## PLANNING STAFF REPORT

**SUBJECT:** *Kevin MacDonald Subdivision - Plan 2023–1 - Miramichi Bay - Parish of Hardwicke*

**MEETING DATE:** March 19<sup>th</sup>, 2024

**AGENDA ITEM:** 2024-2-6

# ATTACHMENT 2 - TENTATIVE SUBDIVISION PLAN

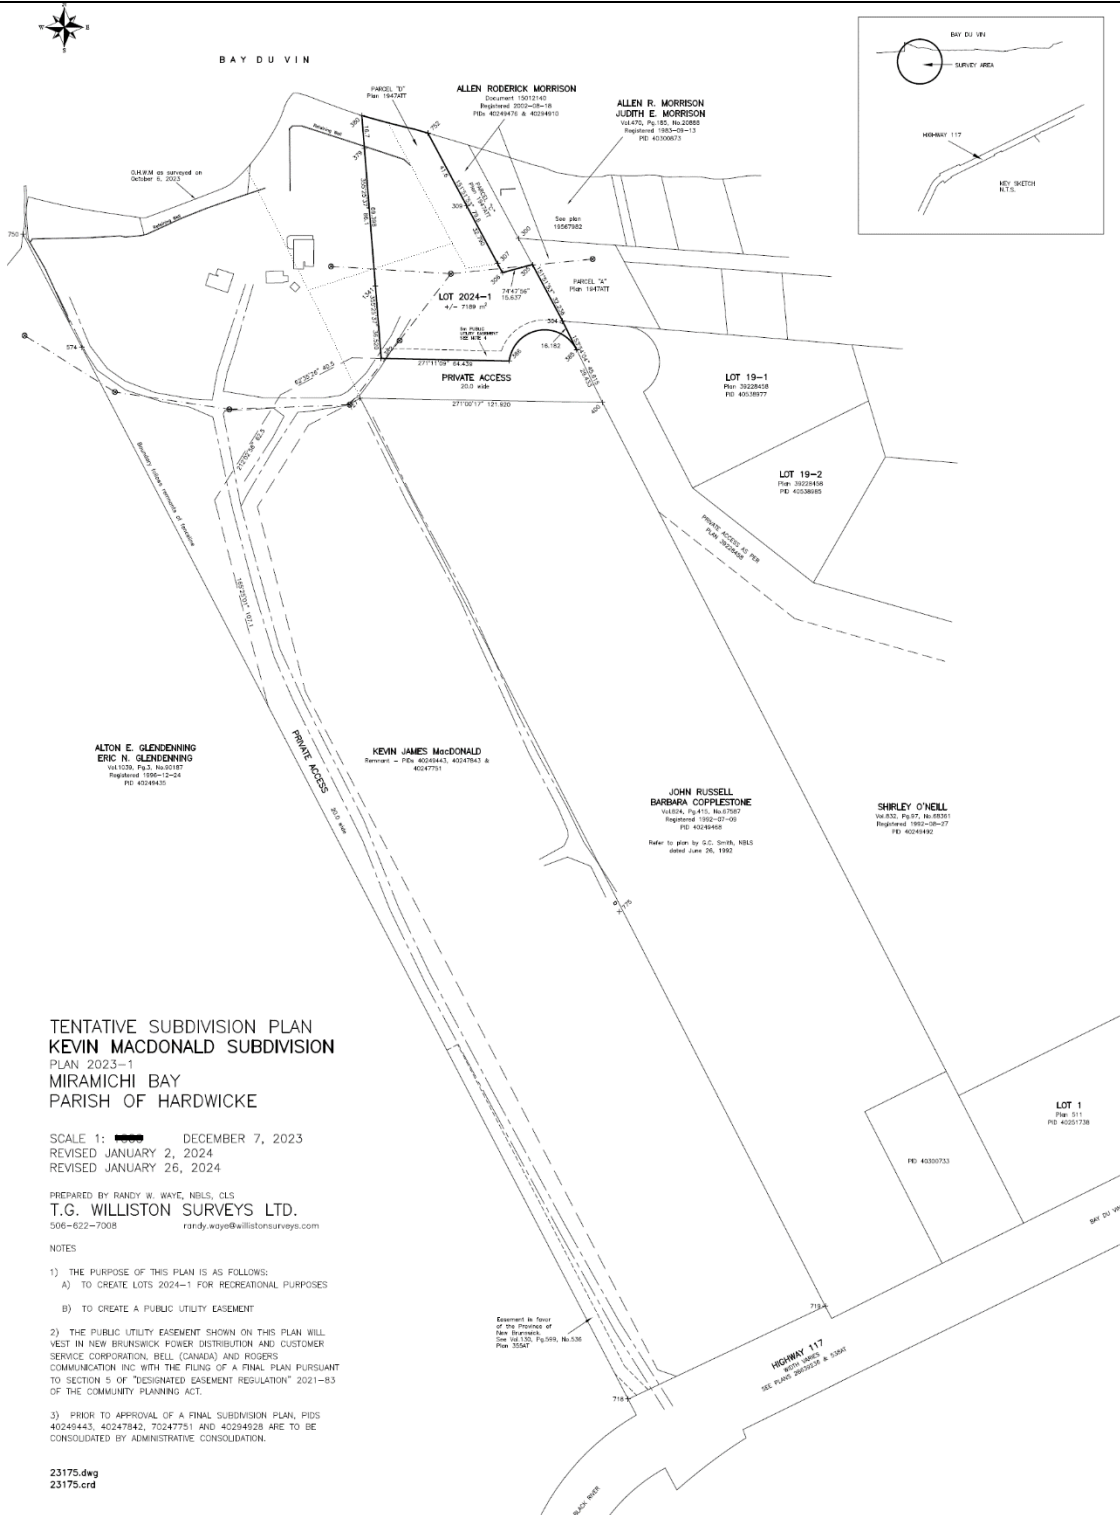
There is already an existing private driveway located over the proposed private access which provides the dwelling access to Route 117, but the private access is required to permit Lot 2024–1 to connect to Route 117, a provincially owned public road. The private access measures 20 metres throughout its width but

has a wider opening on Route 117 to facilitate entry and an 18-metre radius turnaround at the dead-end portion as suggested in Part B Section 1.1(f) of the GMRSC PRAC's *Policy for Private Accesses*. The final plan will need a note mentioning that the Department of Transportation and Infrastructure (DTI) will not upgrade nor maintain this private access and that the property owner is responsible to look after these. As well, the developer shall be advised that the access should be designed to support the expected loads imposed by firefighting equipment, other emergency vehicles, and private services vehicles such as for septic tank maintenance. Therefore, the access should be surfaced with concrete, asphalt or other material designed to permit accessibility under all climatic conditions.

The lot meets the required frontage, depth, and area minimums as per Section 6(4) of the New Brunswick Regulation 80-159 under the *Community Planning Act* (c.19). A subdivision assessment report (soil test) is required for this lot considering that it has less than 8,050 square metres (*New Brunswick Technical Guidelines for On-site Sewage Disposal Systems*, Appendices B and B1). As for the remnant of PIDs 40247751, 40247843, and 40249443, it retains about 8 hectares.

A subdivision inspection report (sight distance) is not necessary since the existing driveway already intersects Route 117. The allowed speed for this section of said route is limited to 80 kilometres per hour which would have required a sight distance of 140 metres.

Other than the Black River, the hydrographic network webmapping from the Department of Natural Resources and Energy Development (DNRED) identifies no presence of watercourses over Lot 2024-1. The wetland webmapping from the Department of Environment and Local Government (DELG) shows no presence of wetland either. However, any alteration taking place within 30 metres of the river may require a permit under the Watercourse and Wetland Alteration Regulation (Reg 90-80) as per subsection 15(2) of the NB *Clean Water Act*.

1. the submission of a subdivision assessment report for Lot 2024-1;
2. the consolidation of PIDs 40247751, 40247843, and 40249443;

“The private access shown on this plan is not suitable for a public street. The Department of Transportation and Infrastructure will not upgrade or maintain this private access and all maintenance services and improvements to the private access are the responsibility of the property owner”; and
